ARCHITECTURAL REVIEW BOARD STAFF REPORT

Project #/Name	ARB-2026-00010: Med Square
Review Type	Review of a Final Site Development Plan and Architectural Design
Parcel Identification	078000000020C8
Location	Approximately 600’ south of the Route 250 East/State Farm Blvd. intersection (Figures 1a and 1b)
Zoned	Planned Development Mixed Commercial (PDMC), Entrance Corridor (EC)
Owner/Applicant	Worrell Land & Development (Andrew Dracopoli)/Woolpert (Shannon Drake)
Magisterial District	Scottsville
Proposal	To construct a new medical office building with associated site improvements.
Context	The site is located approximately 380’ south of Rt. 250 and 340’ east of State Farm Blvd. in the Peter Jefferson Place development. A bank and an office building are located to the north, a museum is to the west, the Sentara Martha Jefferson Hospital is to the south, and the Hilton Garden Inn is to the east. The ground slopes down from west to east and overlooks a series of stormwater ponds.

Figure 2: Site plan showing original layout of ambulance drop-off (left) and revised layout (right).

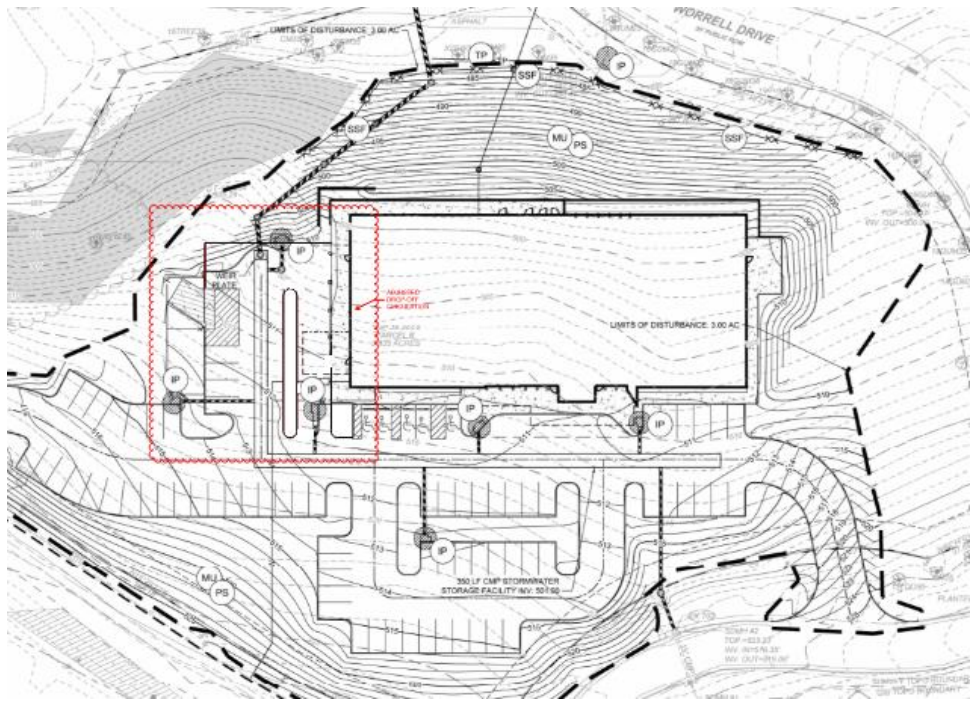
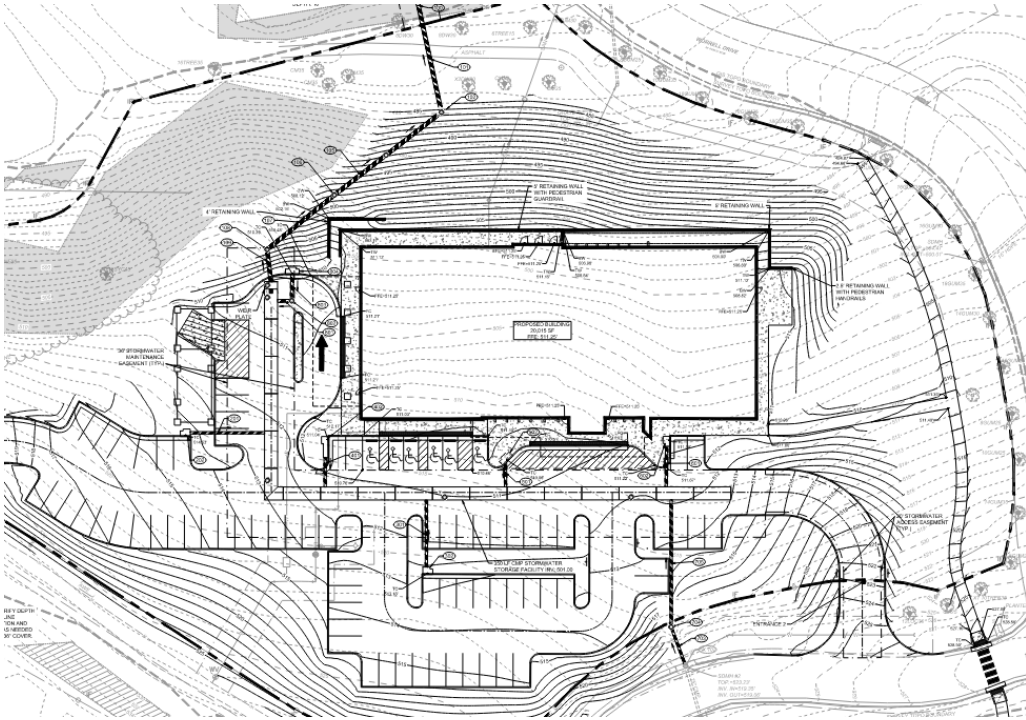
28	In determining the appropriateness of lighting fixtures for the Entrance Corridors, the individual context of the site will be taken into consideration on a case by case basis.		The lighting plan has not been updated to show the revised ambulance drop-off layout.	Revise the lighting plan to coordinate with the revised ambulance drop-off layout.
29	The following note should be included on the lighting plan: "Each outdoor luminaire equipped with a lamp that emits 3,000 or more initial lumens shall be a full cutoff luminaire and shall be arranged or shielded to reflect light away from adjoining residential districts and away from adjacent roads. The spillover of lighting from luminaires onto public roads and property in residential or rural areas zoning districts shall not exceed one half footcandle."		The note does not appear on the lighting plan.	Add the standard lighting note to the plan.

Development pattern			
6	Site development should be sensitive to the existing natural landscape and should contribute to the creation of an organized development plan. This may be accomplished, to the extent practical, by preserving the trees and rolling terrain typical of the area; planting new trees along streets and pedestrian ways and choosing species that reflect native forest elements; insuring that any grading will blend into the surrounding topography thereby creating a continuous landscape; preserving, to the extent practical, existing significant river and stream valleys which may be located on the site and integrating these features into the design of surrounding development; and limiting the building mass and height to a scale that does not overpower the natural settings of the site, or the Entrance Corridor.	None.	The change to the layout of the ambulance drop-off and parking layout at the main entrance are not expected to have a significant visual impact on the EC. The path from the building to the existing walking trail and the sidewalks from the building to the private drive have been deleted from the architectural site plan.	Update the site plan set with all proposed site layout changes. A connection to the walking trail is recommended.

5. Revise the lighting plan to coordinate with the revised ambulance drop-off layout.
6. Add the standard lighting note to the plan: “Each outdoor luminaire equipped with a lamp that emits 3,000 or more initial lumens shall be a full cutoff luminaire and shall be arranged or shielded to reflect light away from adjoining residential districts and away from adjacent roads. The spillover of lighting from luminaires onto public roads and property in residential or rural areas zoning districts shall not exceed one half footcandle.”

7. In the plant schedules, change *Myrica cerifera* to *Morella cerifera*.
8. Update the site plan set with all proposed site layout changes.
9. A connection to the walking trail is recommended.
